Compliance with Approval Condition (h)
Planning Application No. A/YL-TYST/1242

**Proposed Temporary Warehouse (excluding Dangerous Goods Godown)
with Ancillary Facilities for a Period of 3 Years in “Residential (Group D)”,
“Residential (Group B) 1” and “Government, Institution or Community” Zones,
Lot 2611 S.A (Part) in D.D. 124 and Adjoining Government Land,
Tan Kwai Tsuen, Yuen Long, New territories**

(S.16 Planning Application No. A/YL-TYST/1242)

Compliance with Approval Condition (f)
Planning Application No. A/YL-TYST/1242

File:	DWG NO.
Scale:	DD124- Lot2611 D1
Rev.	
Date:	05-03-2021

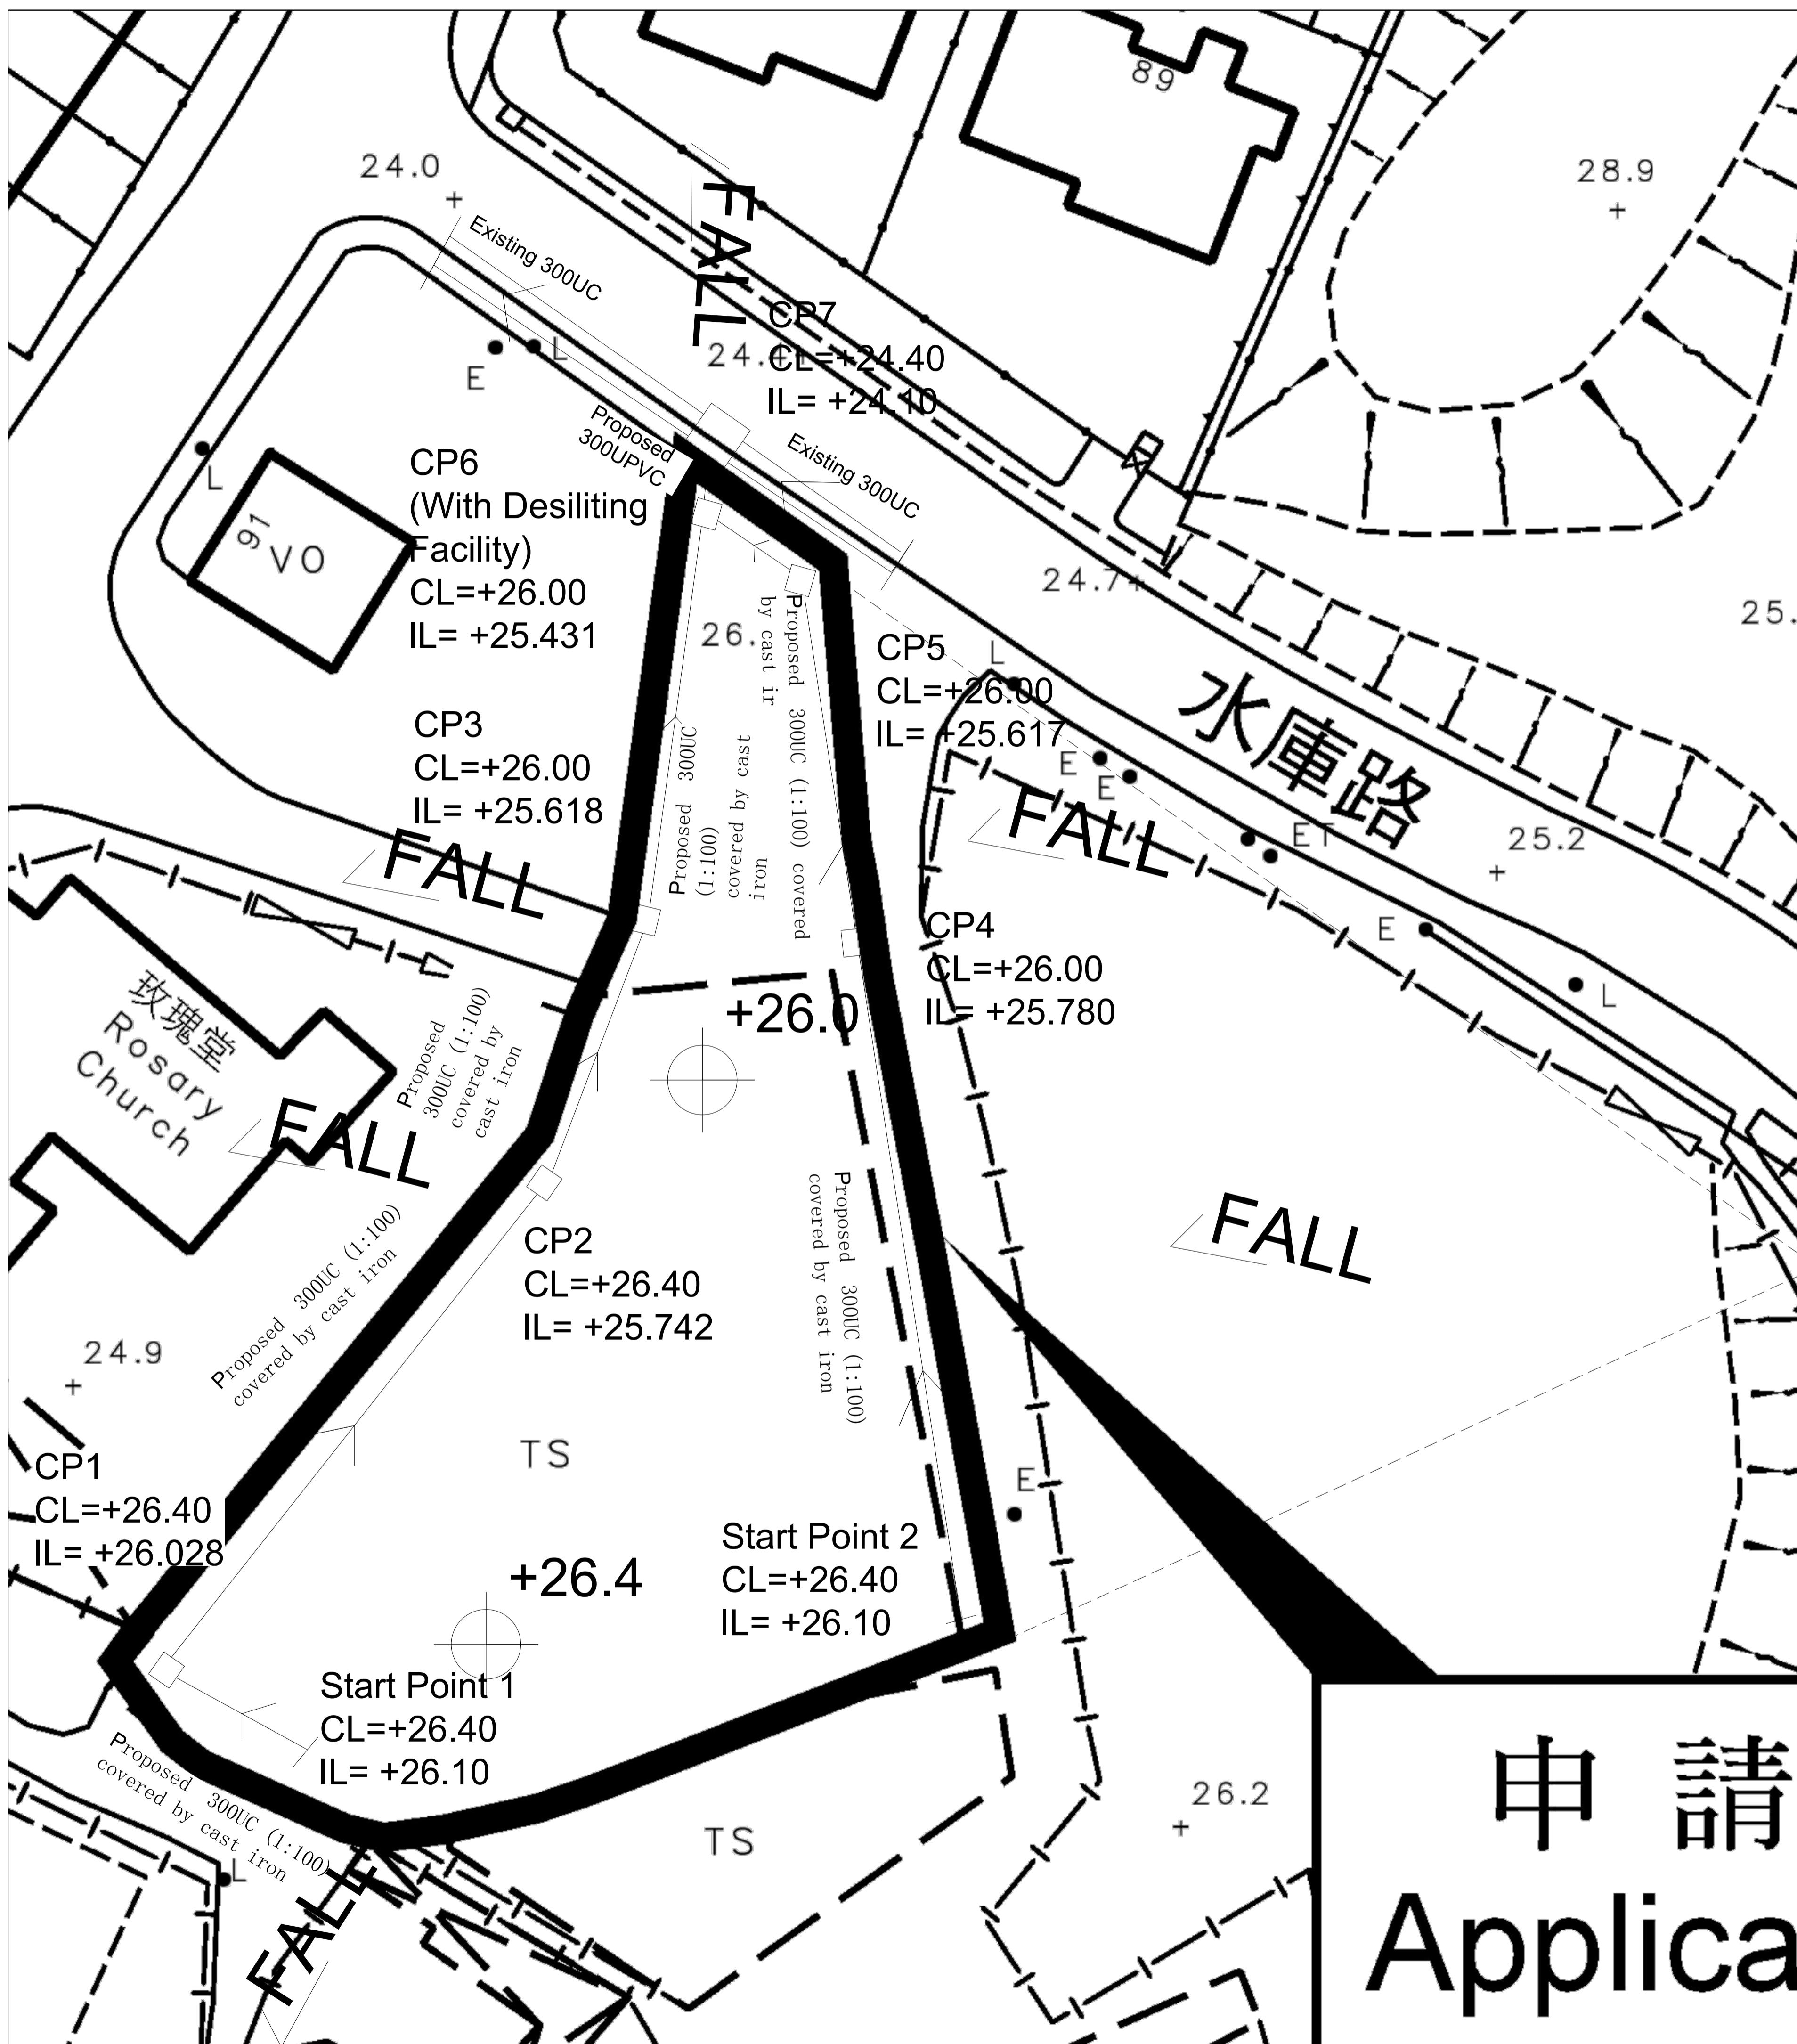
- i) The applicant should implement the drainage facilities on site in accordance with the agreed drainage proposal.
- ii) The applicant is required to rectify the drainage system if they are found to be inadequate or ineffective during operation. The applicant shall also be liable for and shall indemnify claims and demands arising out of damage or nuisance caused by a failure of the drainage system.

- iii) The existing 300mm u-channel, to which the applicant proposed to discharge the stormwater from the subject site was not maintained by this office. The applicant shall resolve any conflict/disagreement arisen for discharging the runoff from the application site to the proposed discharge point(s). In the case that it is a local village drains, District Officer (Yuen Long), Home Affairs Department should be consulted. Moreover, the applicant should ensure that this drainage system and the existing downstream drains/channelsstreams have adequate capacity to convey the additional runoff from the application site. Regular maintenance should be carried out by the applicant to avoid blockage of the system.

- iv) The proposed development would neither obstruct overland flow nor adversely affected any existing natural streams, village drains, ditches and the adjacent areas.

- v) The applicant should resolve any conflict/disagreement with relevant lot owner(s) and seek permission from the District Lands Officer/Yuen Long, Lands Department for laying new drains/channels and/or modifying/upgrading existing ones in other private lots or on Government Land, where required, outside the application site.

**TYPICAL DETAILS
OF RUN-IN
(SHEET 1 OF 2)**

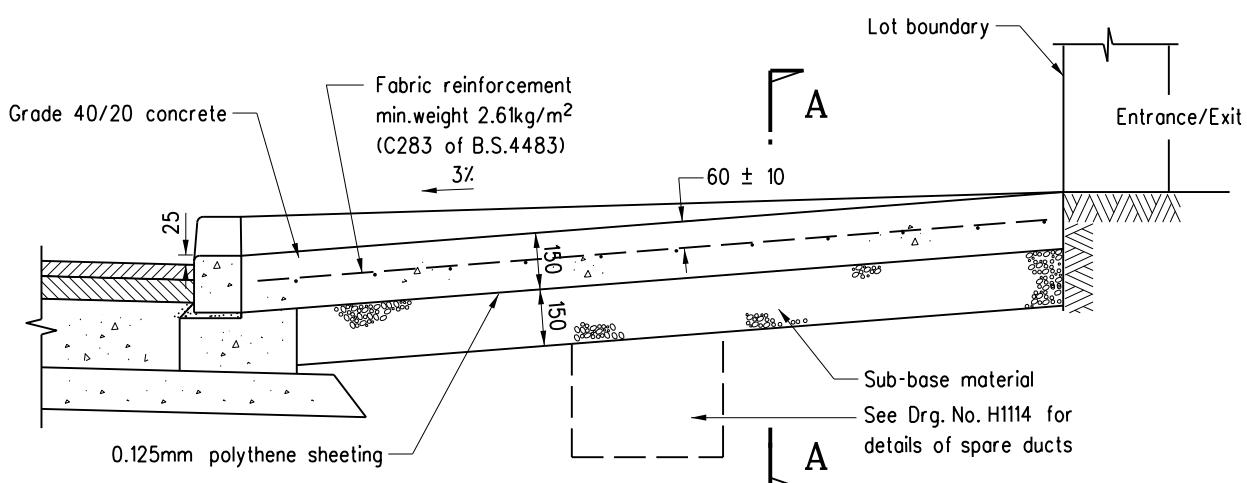
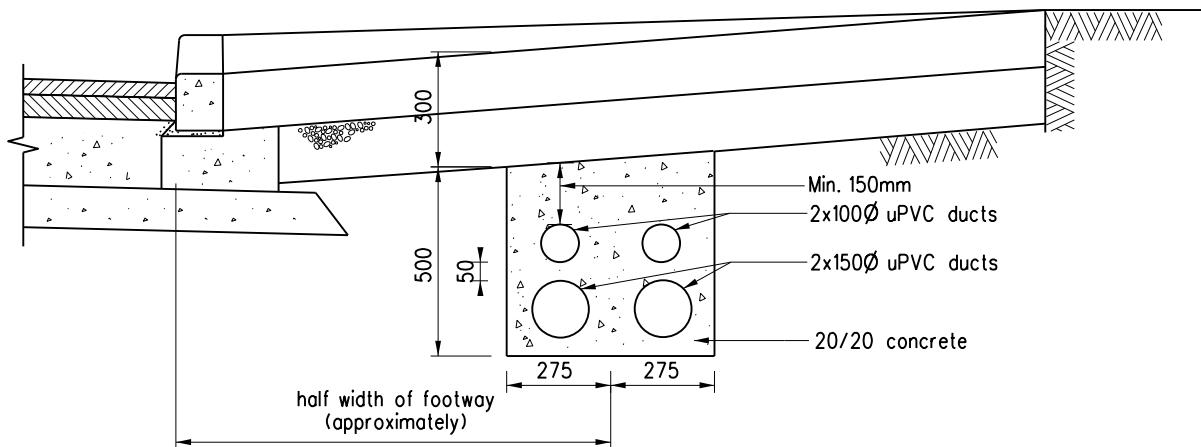
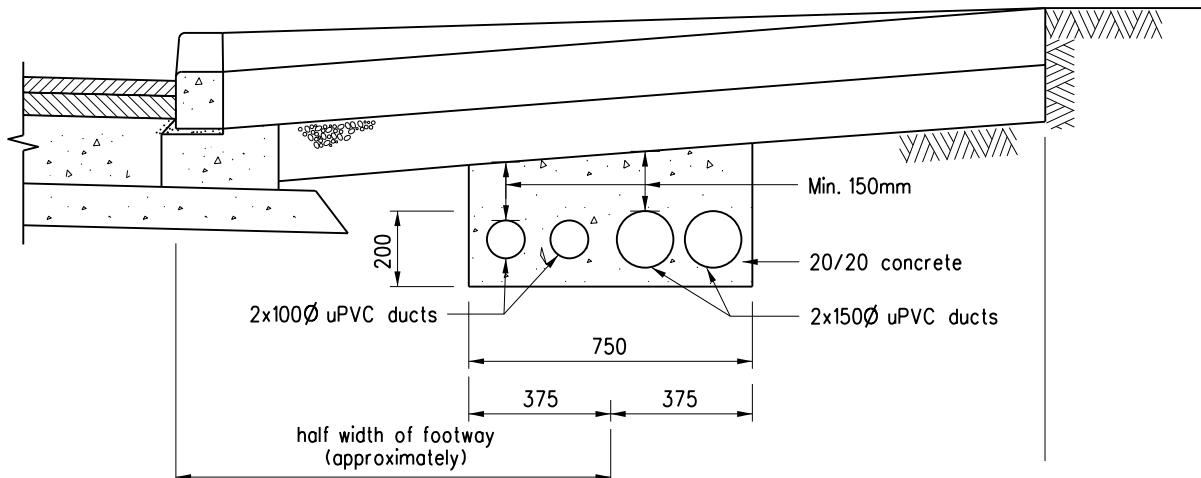
- i) Adequate drainage measures shall be provided to prevent surfacc water running from the application site to the nearby public roads and drains;
- ii) "C ↑ D" marks should be engraved on both sides of the run-in/out indicating the alignment of cross-road ducts;
- iii) Please be reminded to take and maintain photo record of hidden works (e.g. depth and number of cross-road ducts, concrete surround, etc.) for arranging handing over inspection with HyD;
- iv) Please be reminded to maintain record of construction materials (e.g. strength of concrete used, etc.) for arranging handing over inspection with HyD; and
- v) Please note that HyD shall not be responsible for the maintenance of any access connecting between the application site and Shui Fu Road.
